VEPCO NOMAD CODE AND MODEL SUPPLEMENTAL INFORMATION.

Docket # 50-280
Control # 8407170305
Date 7/6/84 of Document:
REGULATORY DOCKET FILE

RESPONSE TO QUESTIONS AND COMMENTS ON VEPCO NOMAD CODE AND MODEL (VEP-NFE-1)

FIGURE 2.1

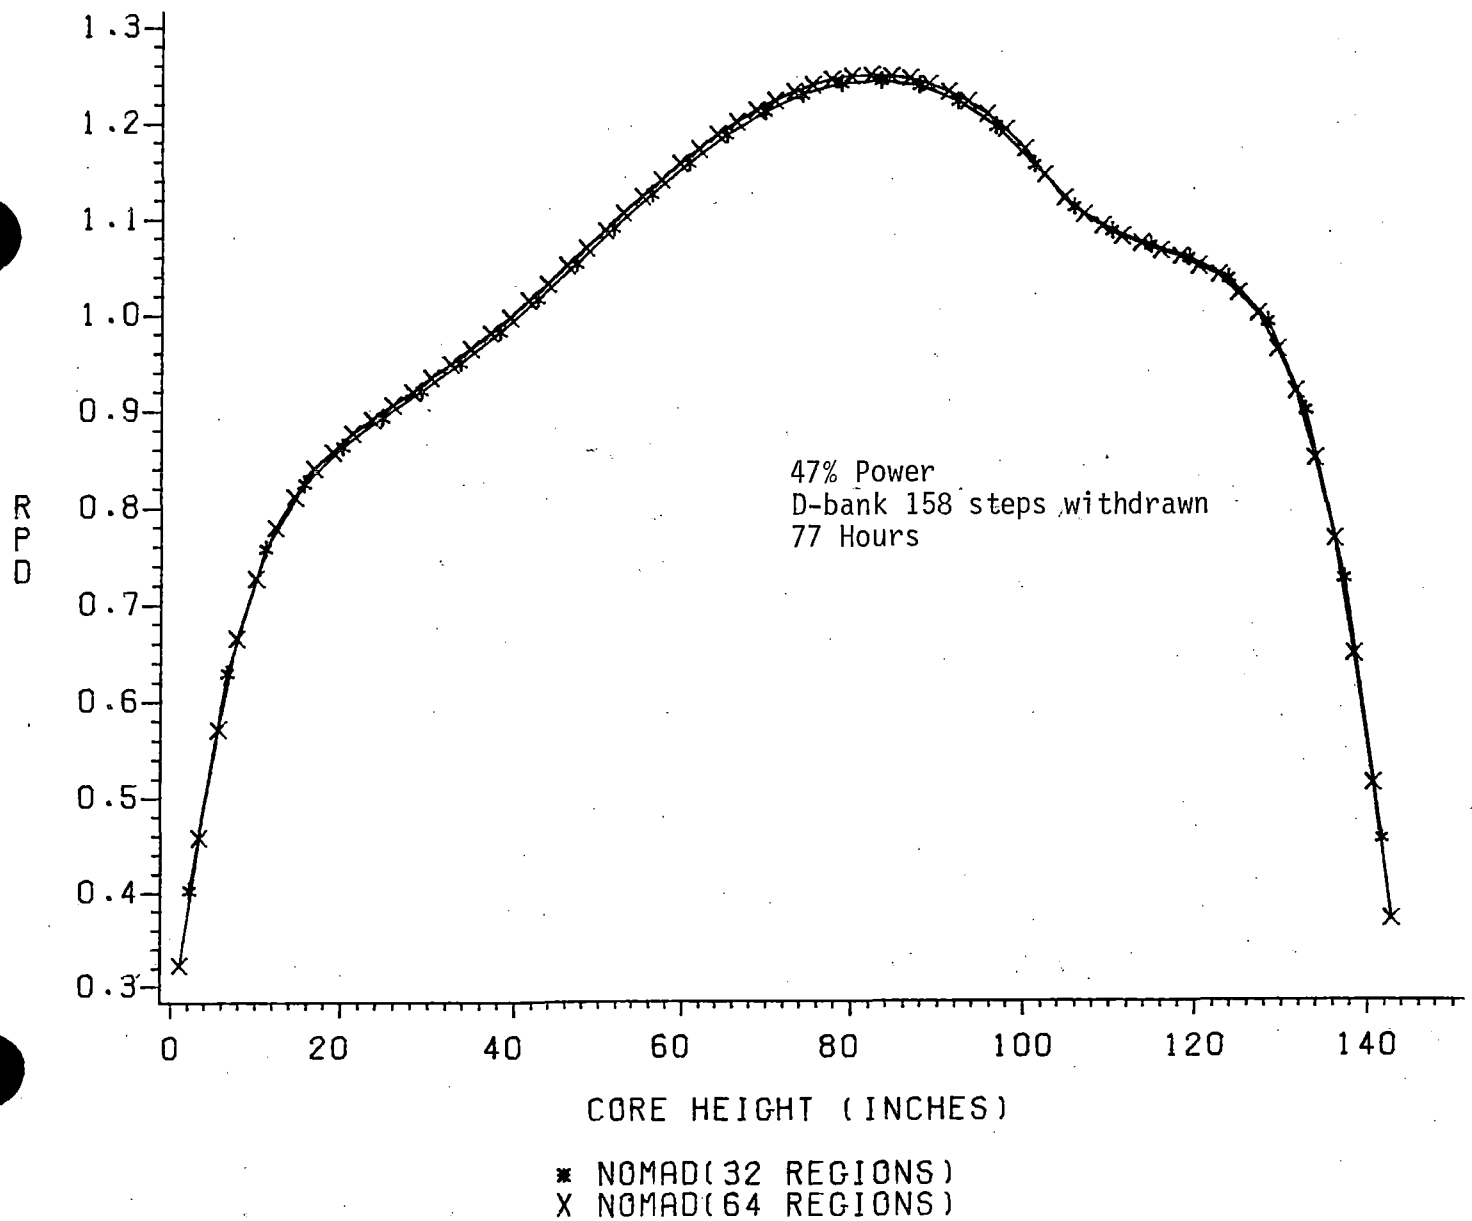
Question 1. The NOMAD model represents the fuel by 32 axial regions.

This implies an axial mesh spacing of more than 11 cm which is large for an explicit 2-group, finite difference code, particularly in light of studies of the dependence of finite difference generated results to mesh spacing.

To demonstrate the accuracy of the 32 axial region model, one of the load follow maneuvers from Section 5.6 (N1C3 Shutdown/Return to Power Case 1) was performed with the 32 axial region model and with a 64 axial region model. Figures 1.1 and 1.2 show virtually identical results for delta-I and critical boron concentration throughout the case. Figures 1.3 through 1.8 show comparisons of axial power distributions calculated at specific

timesteps during the load follow simulation. The 32 region model local power predictions are never more than 0.9% less than the 64 region model results for any of these cases.

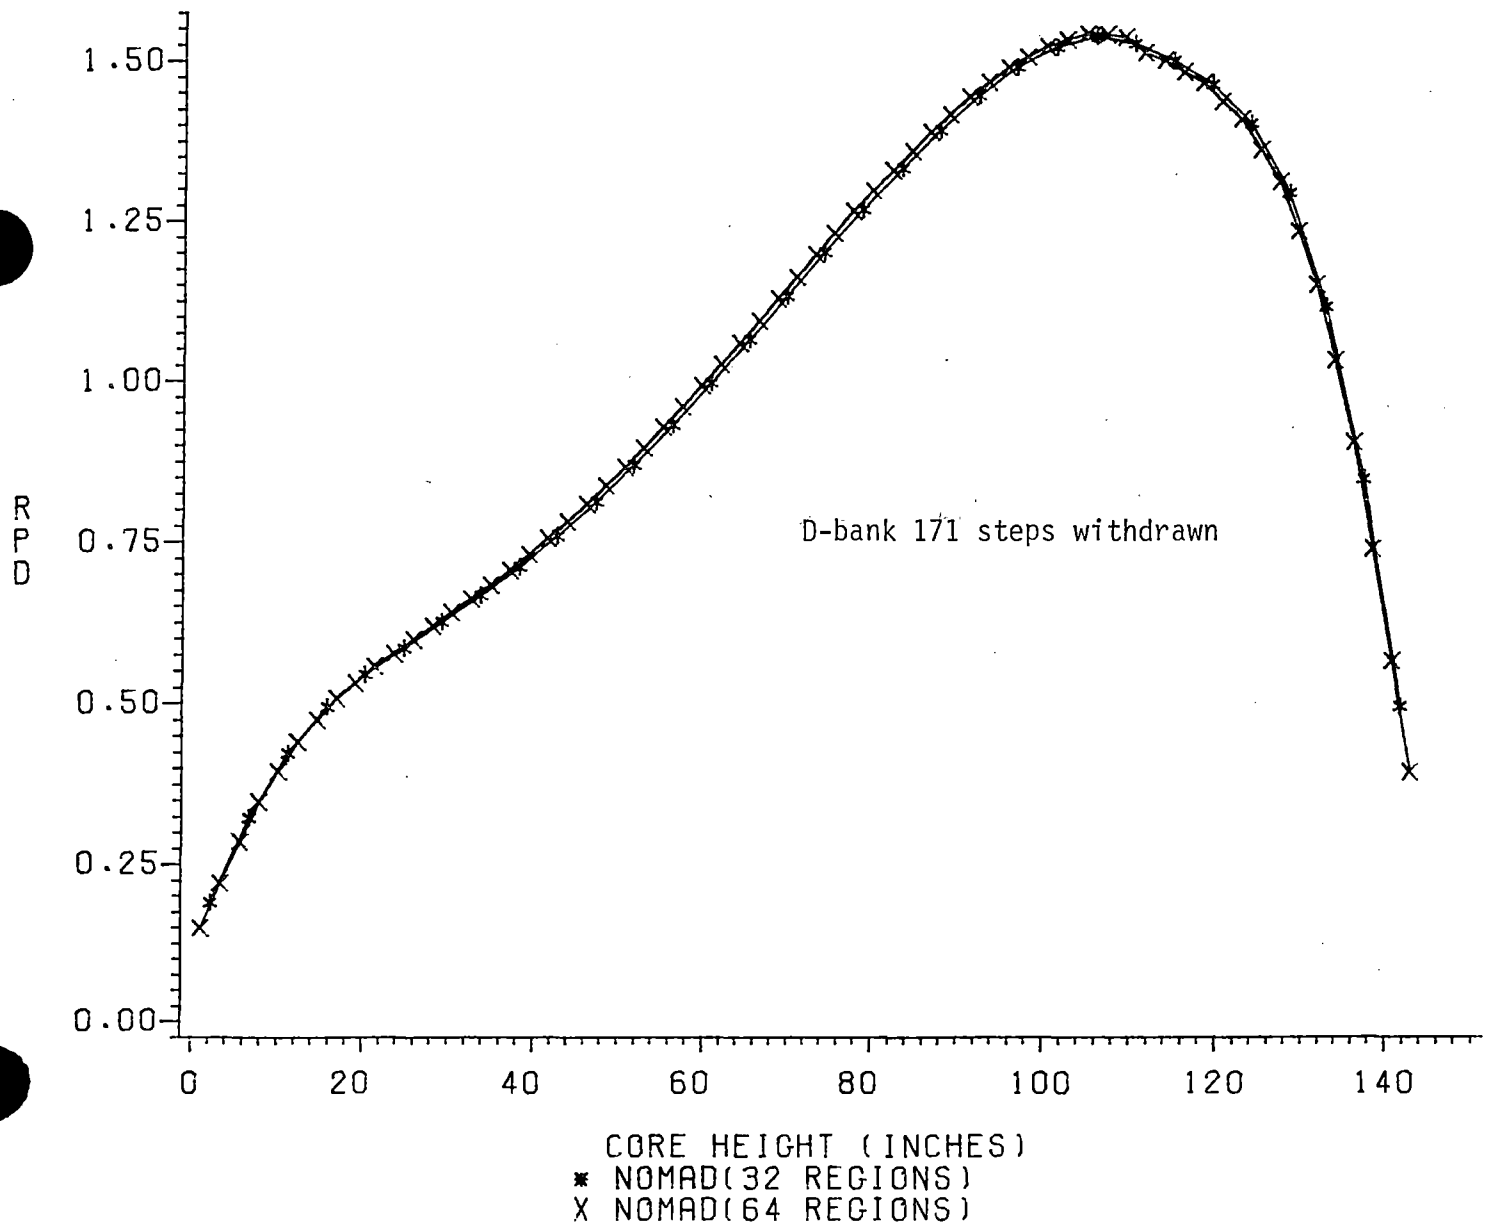
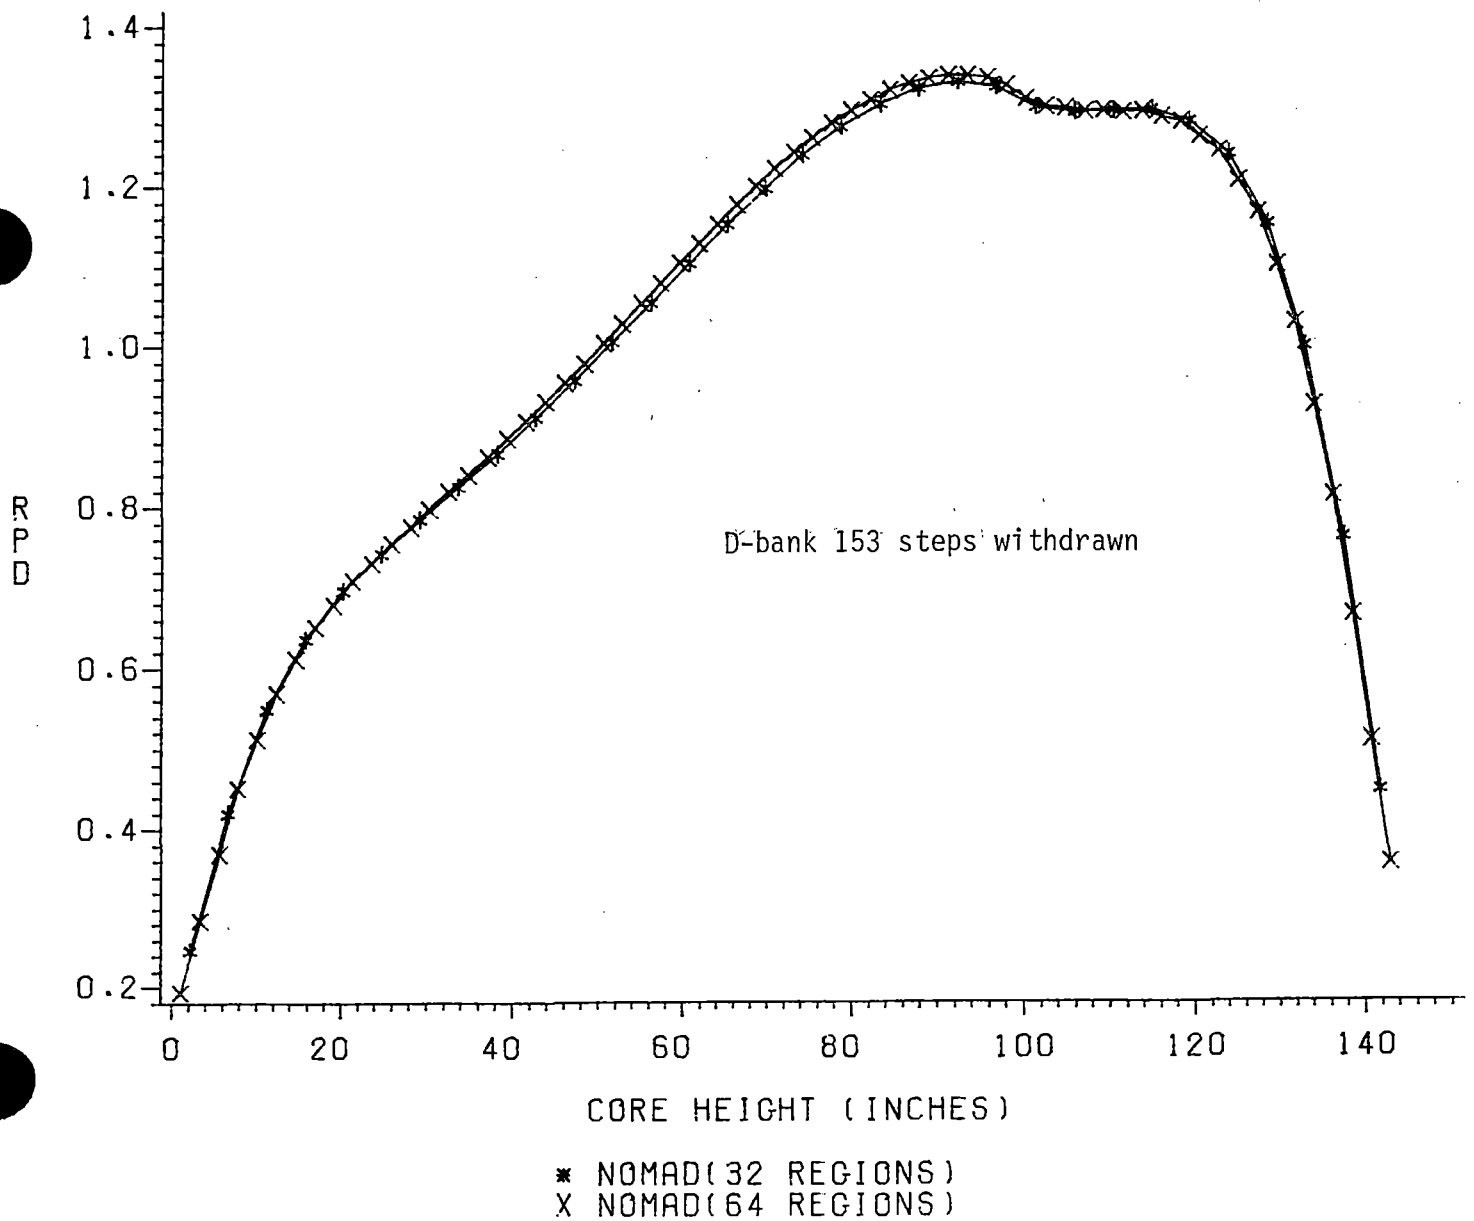
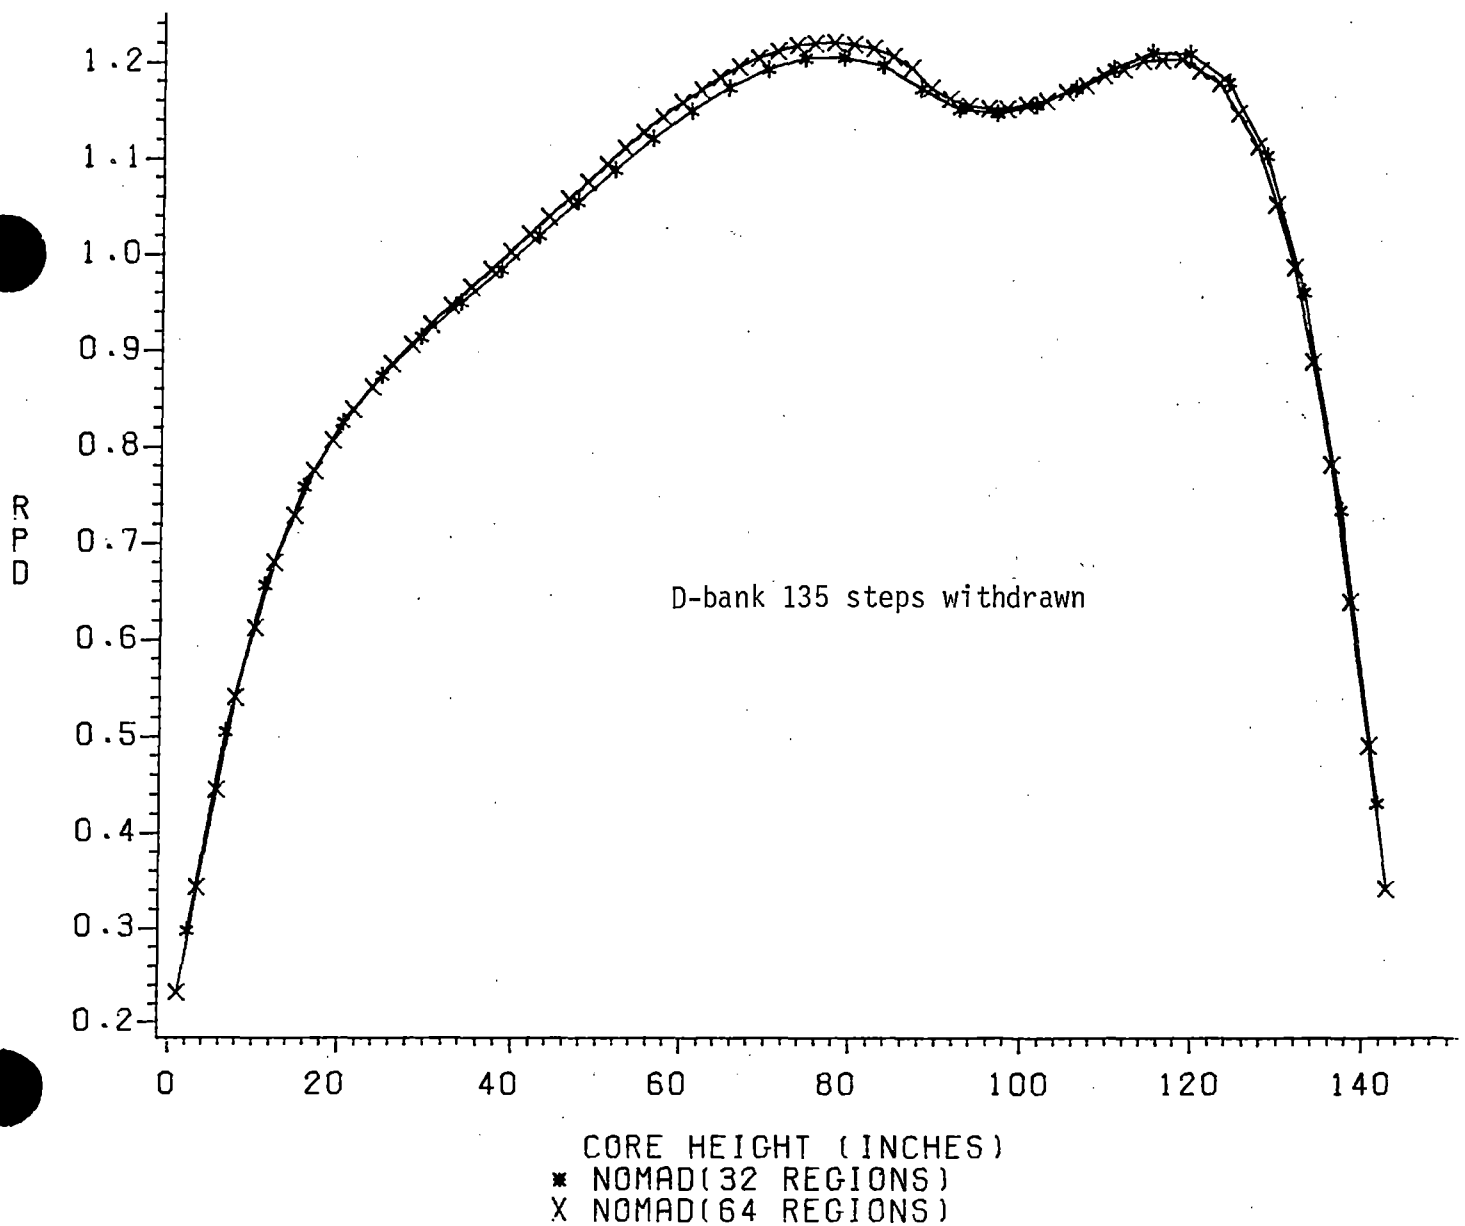
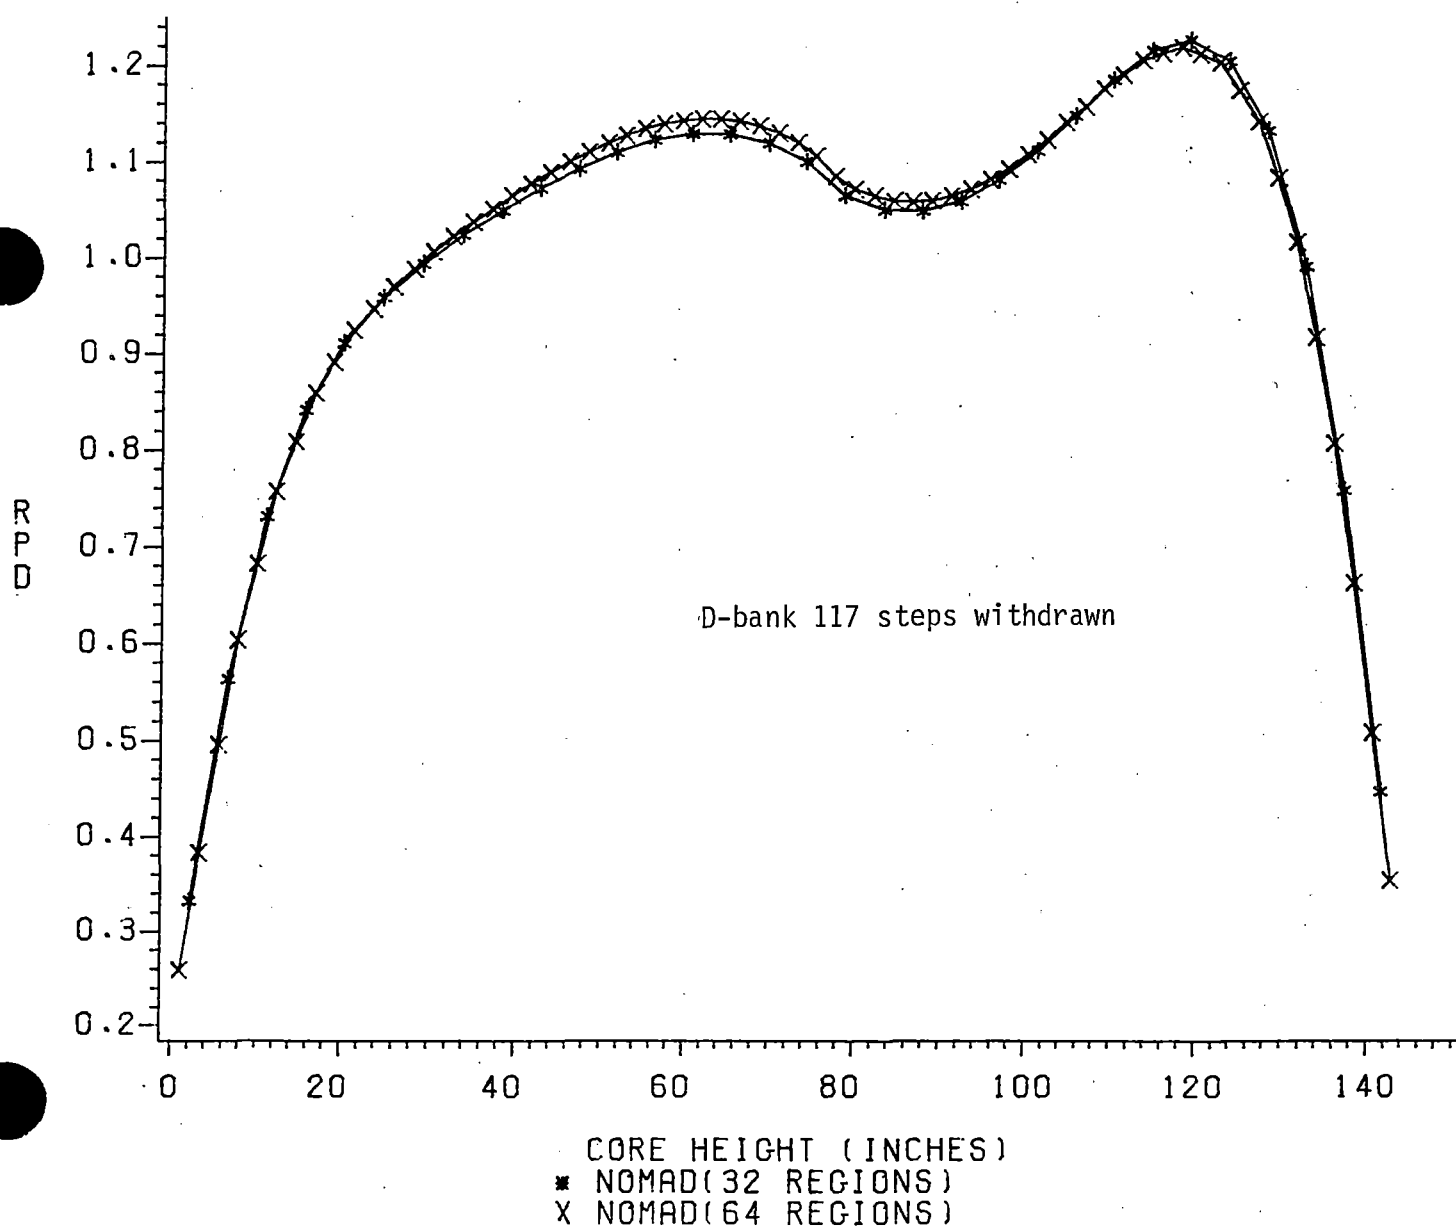
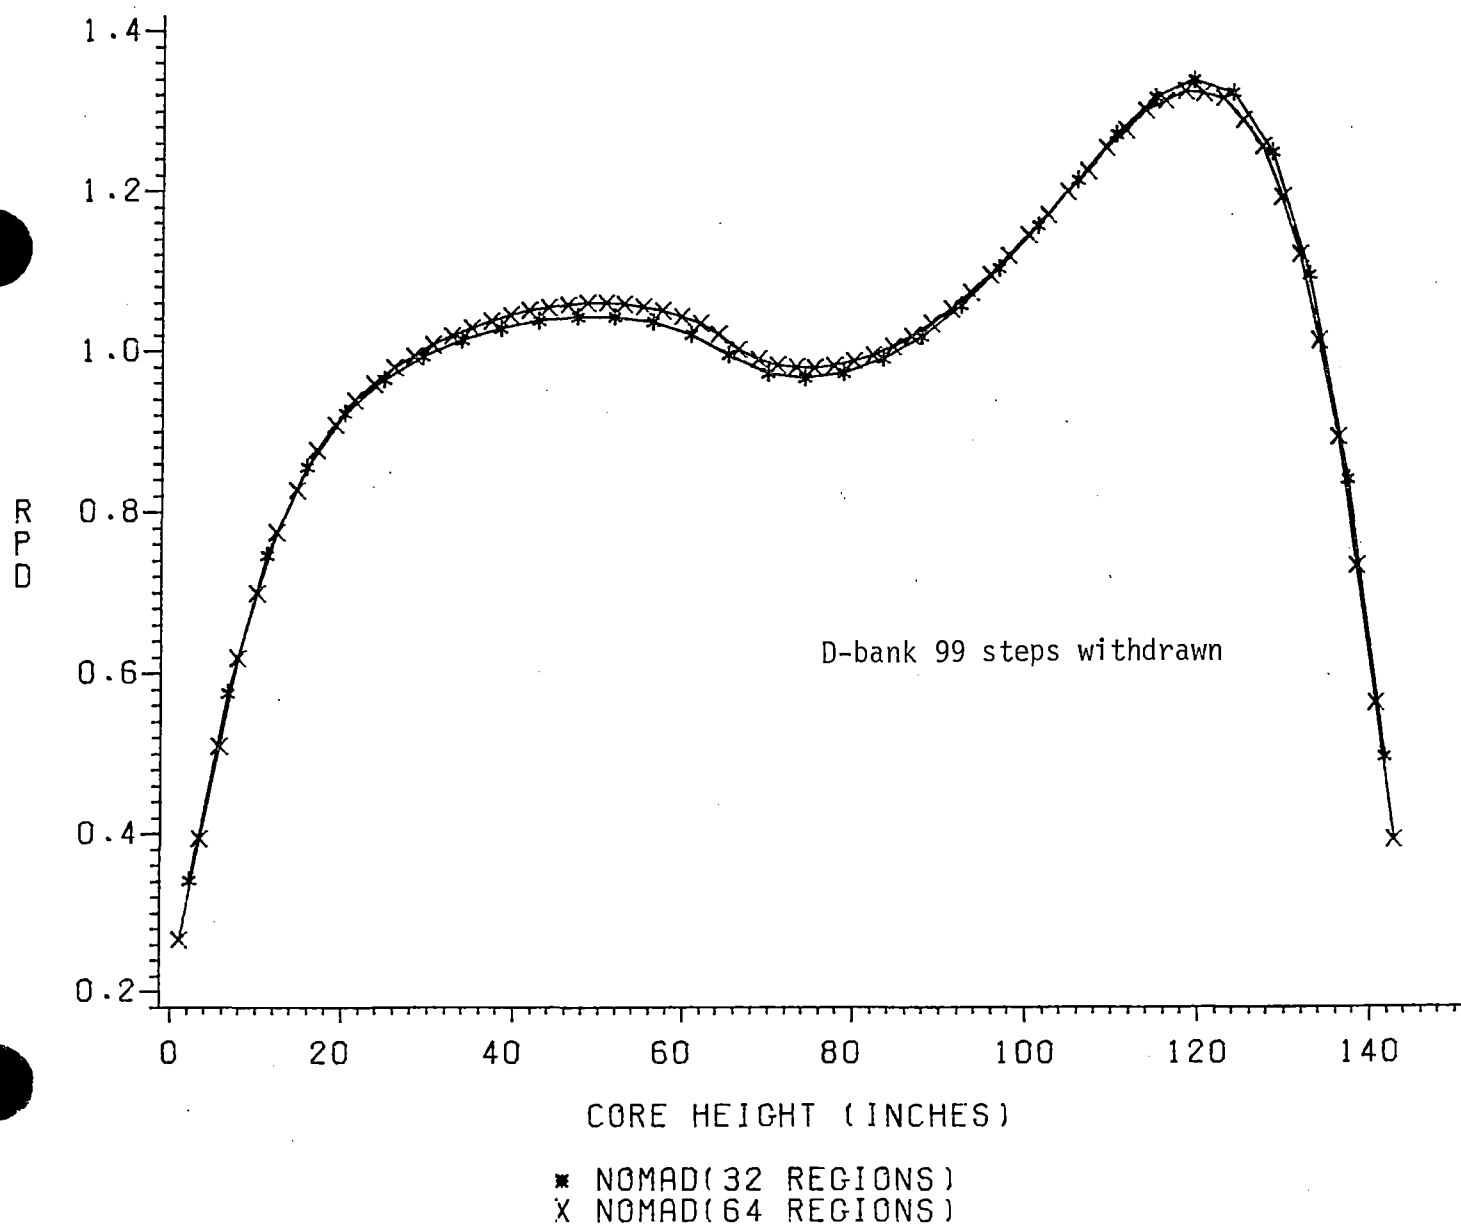
Question 2. The treatment of rod insertions which fall between axial zone boundaries is not described nor is its adequacy.

To demonstrate the adequacy of the model for rod insertions which fall between axial region boundaries, a series of calculations were performed with the 32 axial region model and the 64 axial region model. A control rod bank was inserted to various positions, each position corresponding exactly to a mesh boundary between two axial regions in the 64 region model and to the center of an axial region in the 32 region model. The axial power distributions from these calculations are compared in Figures 2.1 through 2.5. The local power predictions from the 32 region model are never more than 1.6% less than the 64 region results.
